# PLANNING COMMISSION REPORT NON PUBLIC HEARING ITEM Public Hearing on variance only

ITEM NO 6: PRELIMINARY PLAT FOR NORTH LAWRENCE RIVERFRONT

**PP-2-1-12**: Consider a Preliminary Plat for North Lawrence Riverfront Addition, located at 401 North 2<sup>nd</sup> Street. This subdivision includes variances related to block length, right-of-way dedication for N. 2<sup>nd</sup> Street as a principal arterial, and connection of a local street to an arterial street. Submitted by Paul Werner Architects, for North Mass Redevelopment, LLC, Douglas County Kaw Drainage District, City of Lawrence, Kaw River Estates, LLC, HDD of Lawrence LLC, D & D Rentals of Lawrence LLC, Jeffrey W. Hatfield, Exchange Holdings LLC, Loosehead Investments LLC, and Riverfront Properties of Lawrence LLC, property owners of record.

Figure 3: Block Length Exhibit

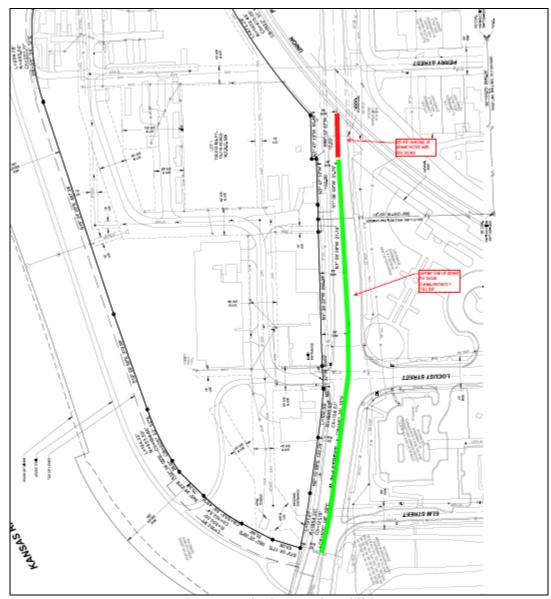
The block length of the street frontage of  $N.\ 2^{nd}$  Street is 792.89', excluding the 95.46' that overlay with the railroad right of way.

The green line in the above graphic highlights the street frontage used for measuring block length. The red line highlights that segment of the street right-of-way that overlaps with the railroad right-of-way. It is in that north 95' that the street continues north through an underpass. Conservatively, to comply with the subdivision regulations, a variance is needed regarding block length.

# VARIANCE NO. 1: Block length in excess of 800 feet per Section 20-810 (d).

- 1. Staff recommends approval of a block length in excess of 800'.
- 2. Staff recommends approval of reduced right-of-way dedication for N. 2<sup>nd</sup> Street as a principal arterial street.

Figure 5: N. 2nd Street Bridge and Bowersock Dam Access

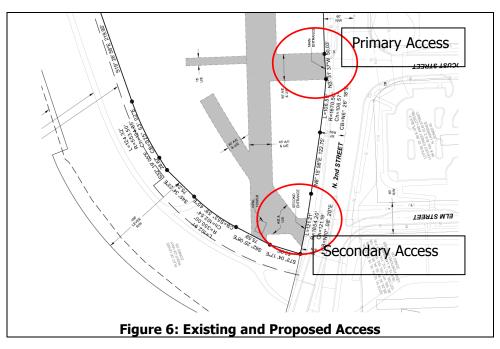
Access to Bowersock Dam, Riverfront Park and the KP&L tower are located at the south end of the property. Access to these facilities must be maintained. The access easement, as proposed, provides connectivity but much of the access is obstructed by the KP&L tower. The easement will need to be adjusted to comply with this design requirement. This requirement is reflected as a condition of approval.

1. Provision of a revised drawing to include access around tower per staff approval.

Figure 7: Image shows location of trail, tower and existing access to trail.

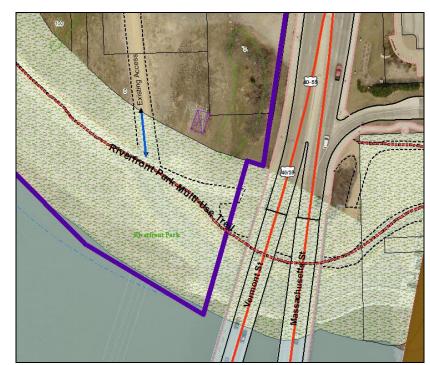
The area at the south end of the project represents the lowest level of the site making the levee trail accessible. This accessibility will need to be maintained. Additionally, the KP&L tower located at the south end will also remain. The Preliminary Plat, as proposed, shows access to the public levee trail aligned with the tower. As noted earlier this access will need to be adjusted.

of the subject property. Access is accommodated through tracts of land owned by the City of Lawrence. The existing KP&L tower is proposed to remain in the redevelopment plans for this property. Access to the tower, levee and Bowersock Dam must also be maintained.
